UNITED STATES DEPARTMENT OF COMMERCE
Patent and Trademark Office

Office Action Summary

This is the first office action for application number 09/629,241, Wiring Clip for Securing Electrical Wiring to a Framing Member, filed on July 31, 2000.

2,631,809

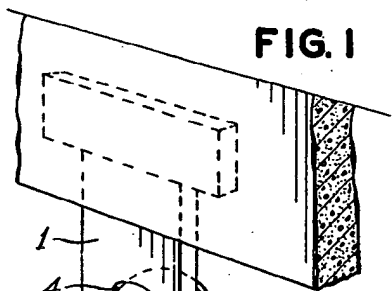
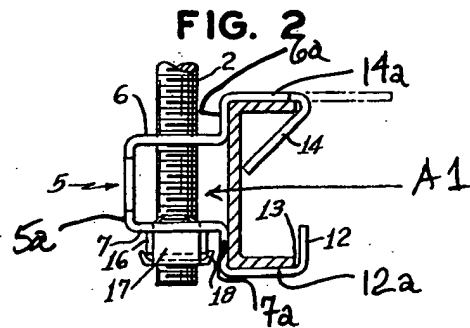
Claims 1, 5-10 and 12-13 are rejected under 35 U.S.C. 102(b) as being anticipated by U.S. Patent 2,631,809 to Jacobson. Jacobson discloses a wiring clip 5 (note attached marked-up copy of Figs. 1-2) including the following: a main body 5,5a,6,6a,7,7a; a wire receiving area A1 adjacent the main body; and, first and second arms 14a,12a each with respective first and second attachment means for attaching 14,12 located at first and second ends respectively. Jacobson also discloses that the first and second attachment means has a J-hook and a bend respectively. Finally, Jacobson disclose that the clip is dimensioned and made of thin metal or plastic for allowing a screw to penetrate the clip.
